AGENDA
HAILEY PLANNING & ZONING COMMISSION
Tuesday, February 16, 2021
Virtual Meeting
5:30 p.m.

STAFF REPORT
Hailey Planning and Zoning Commission
Regular Meeting of February 16, 2021

STAFF REPORT
Hailey Planning and Zoning Commission
Regular Meeting of February 16, 2021

To: Hailey Planning and Zoning Commission

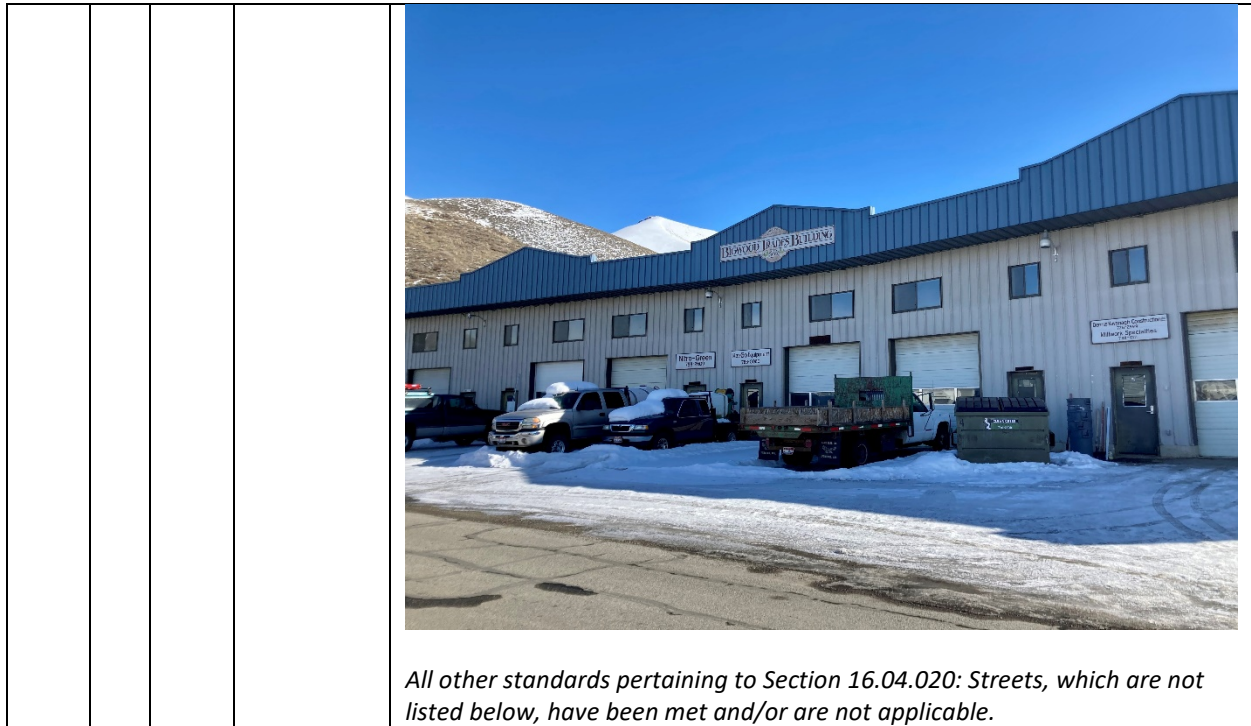
<i>Staff Comments</i>	<i>The parcel is a corner parcel and is surrounded on three (3) sides by public streets: Glenbrook Drive, Mountain Drive and Black Oak Drive. These streets are existing and can safely accommodate existing and anticipated traffic. The building is existing and there are six (6) garage bays that gain access from Mountain Drive.</i>

Staff is also proposing to add the figure below (found in Section 17.04B.050) to Section 17.04C.050(A): Bulk Requirements of the General Residential (GR) Zoning District:

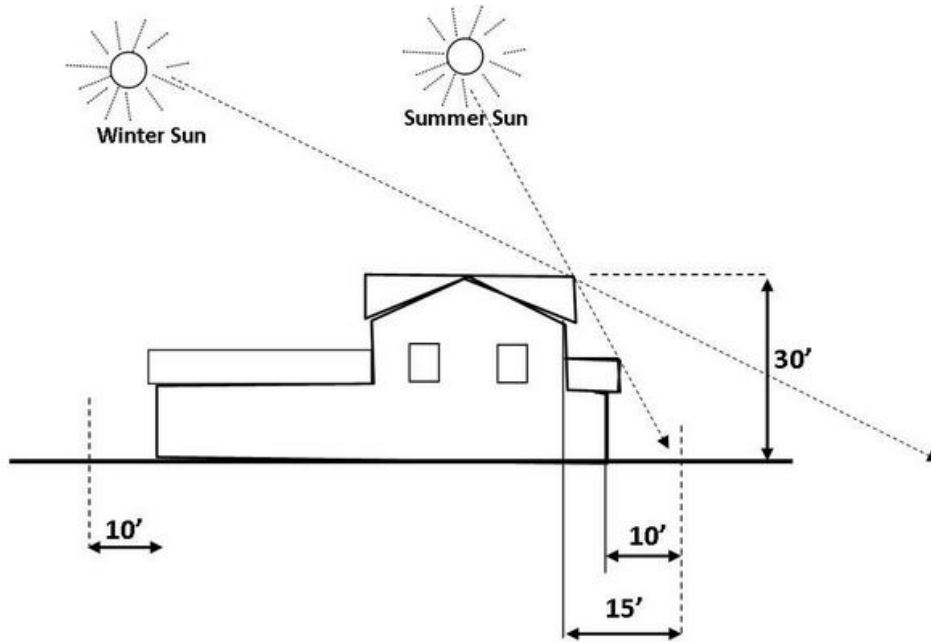
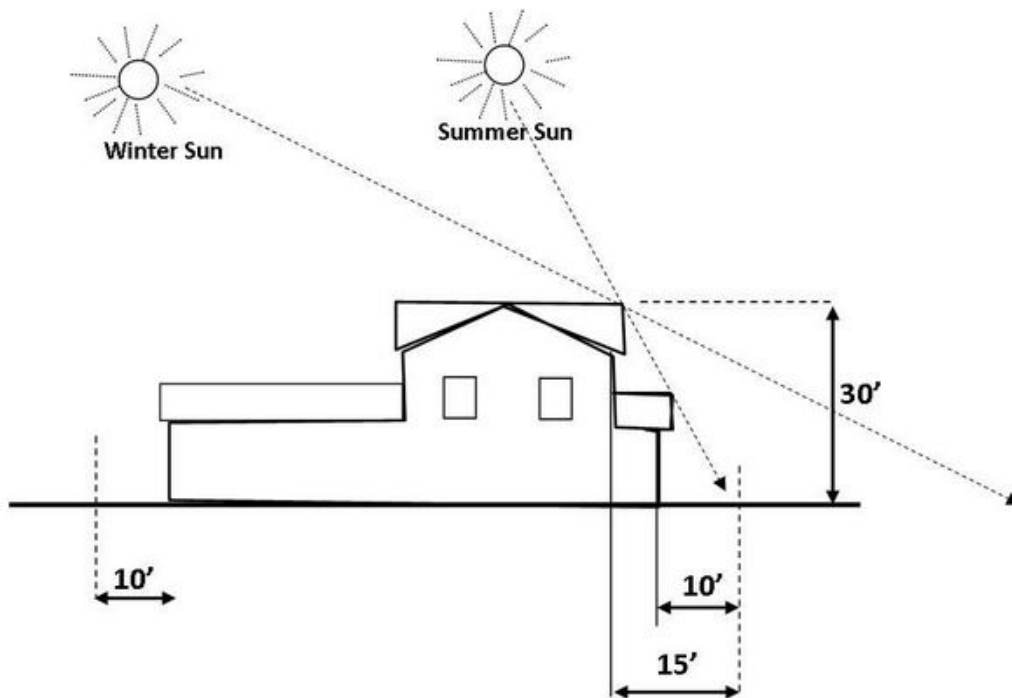
Background: City Planning Staff has listed minor code amendments as a priority for 2021. As such, Staff is proposing to amend the General Residential (GR) Zoning District setbacks to include existing Note #3:

The setback from the adjacent property shall be one (1) foot for every two (2) feet of building height for all portions of the building exceeding twenty (20) feet in height, provided; however, no side or rear yard shall be less than ten (10) feet. See the figure located at Section 17.04B.050 of this title for more explanation.

Note #3 and the figure above apply to all residential zoning districts within the City, except the GR Zoning District. With various housing opportunities available in Hailey, including Accessory Dwelling Units (ADUs) now permitted City-wide, Staff finds it appropriate to amend and update the Municipal Code to reflect the above provision in all residential zones, including the GR Zoning District.

Furthermore, by applying Note #3 and the figure above to the GR Zoning District, further consistency in code language and bulk requirements can be found across residential zoning districts.

Staff would like to further amend Note #3 to include, “...excluding sublots within a development...” to existing Note #3, as shown above. For those parcels where sublots can be created and utilized for townhome and cottage developments, Staff finds that by excluding the interior setbacks of the development from this standard, more flexibility is given to those parcels that allow for cottage-style developments and the likes. Additionally, this note shall apply to perimeter setbacks from adjacent properties within this same development.
